APPENDIX H

DRAFT CONDITIONS

1. Scheme plan showing flood extents
2. Golovin Flood report including Beca peer review and Golovin response
3. Road Flooding assessment
4. Extract from Australian Rainfall and Runoff
5. Reply to Beca Review 2

Westlands Subdivision Response to Beca Review

Figure 3.3 – Hydraulic grade-line for the 100- and 20-year flows

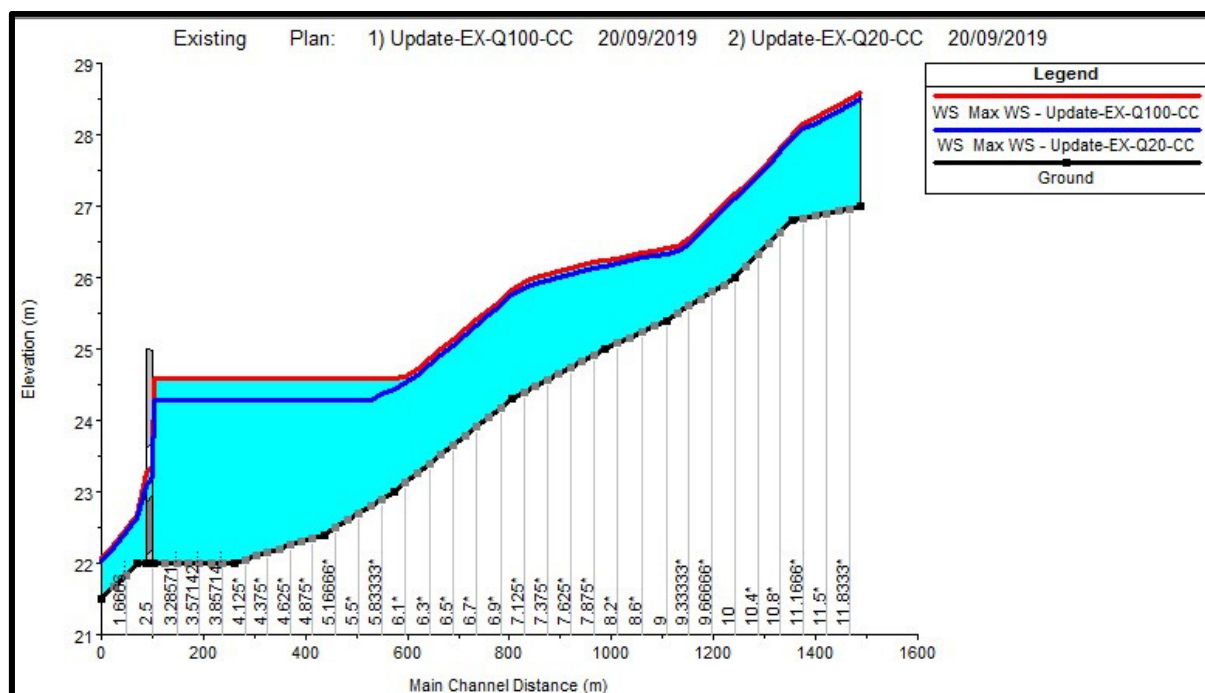
13	Section 3.2 first paragraph –wording is unclear. Please revise	This has been remedied
14	The downstream boundary location is not show on map. Please show and clarify this is sufficiently far enough downstream i.e. there are no further controls downstream that could influence the culvert performance.	This has been remedied. Site inspection shows that downstream controls will be irrelevant. A Normal slope is fine and is shown by the HGL to fine due to the upstream flood levels.
15	Downstream boundary slope is set at 0.1%. Please clarify how this was calculated and applied to the model. Figure 3.3 shows what appears to be a much steeper slope of 0.42. Downstream contours used to calculate a slope over 540m found it to be 0.007 (0.7%).	This has been remedied. See Section 3.2.
16	Figure 3.4/3.5 please update. The legend/labels to state 10yr and 100yr flows/HGL are shown but are not in the figure. Figure 3.4 are not HGL plots.	These have been remedied

Figure 3.3 shows the hydraulic grade-line for the whole reach. There is a uniform flow until RS6 where the effect of the culvert creates a flat hydraulic grade. The 100-year peak level at the culvert is RL24.6m.

Figure 4.1 – Hydraulic grade-line comparing a 50% blockage

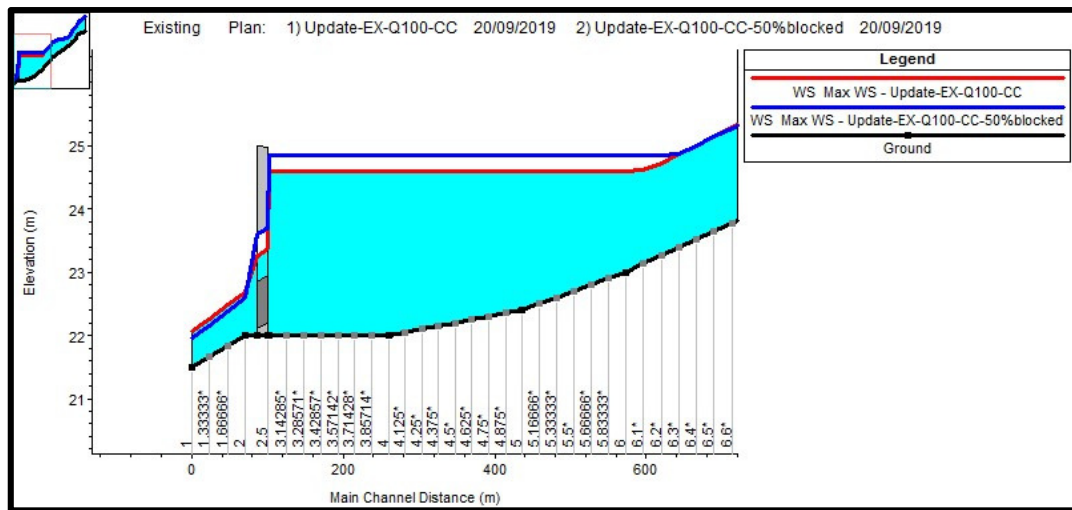
3(b) above - Specifically we need to understand the flooding effect of the culvert under the road being blocked, however unlikely, on the proposed building platforms. What would the wastewater field levels look like now and any change should the culvert block.

The hydraulic model was re-run with the 100-year storm and the bottom 0.75m of the culvert blocked.

Figure 4.1 shows the hydraulic profiles along the reach comparing the non-blocked and 50% blocked. The 50% blockage effects cross-sections just upstream of RS6. The increase in water level at the culvert is 0.2m. The flow is decreased from $6.2\text{m}^3/\text{s}$ to $3.6\text{m}^3/\text{s}$.

Figure 2 – Lot 7 raised driveway HGL

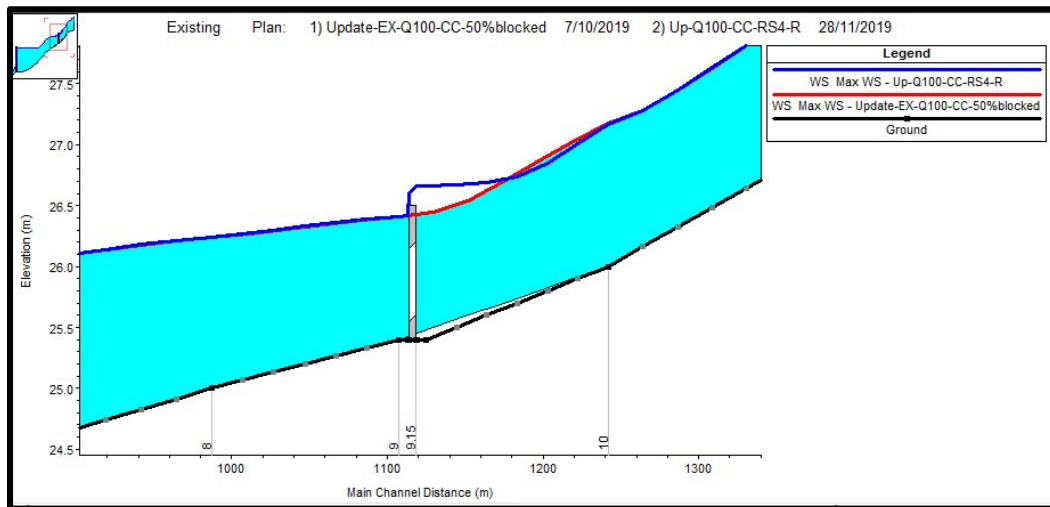
Check that the ROW / Access road is at or above 100-year level. Steven suggest it is the climate change option. Will draw profiles and check "blockage" of road on flood levels if necessary.

For Lot 7 the driveway cuts across overland flows. The ground level is about RL26m and the flood level is RL26.4m. This suggests a 400mm raising of the driveway. This may have an impact for the neighbours at Lot 39 DPS 76270 and Lot 1 12807. RS9 was adjusted by inserting a nominal 600mm culvert and driveway at RL26.5m. Figure 2 shows the change in HGL. Although the water level rises to get over the driveway the influence at RS10 diminishes to zero. This location is the neighbouring upstream boundary.

In conclusion, raising the roadway in Lot 10 requires the FFL of Lot 1 to be raised by 30mm. Within Lot 7 a culvert needs to be under the driveway to drain the area but its design and raised driveway does should not affect neighbouring properties.

Figure 3 – Lot 1 subcatchment

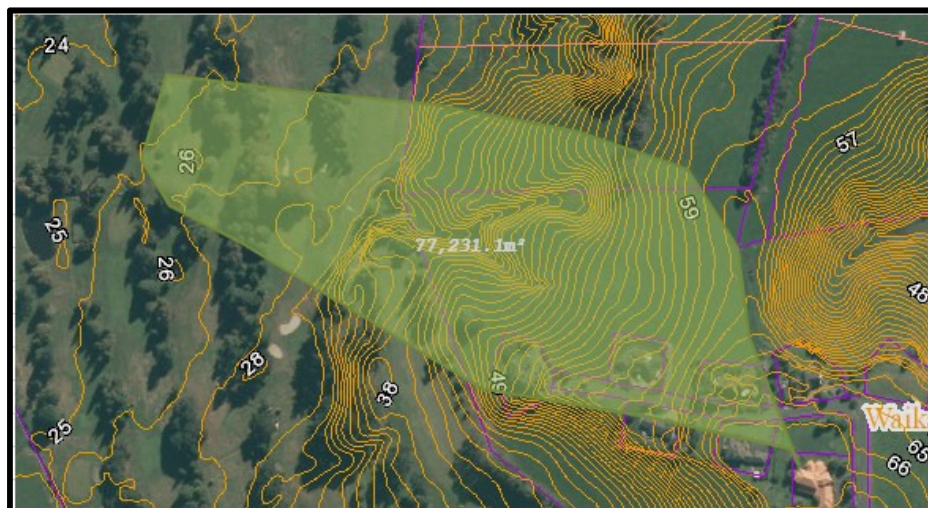
- *Impact for each of the proposed house locations by the overland flowpath. Do the FFLs need to be raised above “normal” ground levels?*

The catchments for Lots 1 and 7 were analysed. The lot 1 catchment is the largest example for houses in Lots 2, 3, 4, 5 and 10. While Lot 7 has a catchment size based on the adjacent drain. These are shown in Figures 3 and 4.

At Lot 1 if the flow width is 24m or more the depth of flow is less than 100mm. For Lot 7 it is 23m. Close examination of the ground profiles there is no concentration of flows but general sheet flow. The widths of the Lots are about 40-50m and therefore the flow depths will be less than 100mm and the allowance for OLFP is within the normal building regulations for ground clearance.
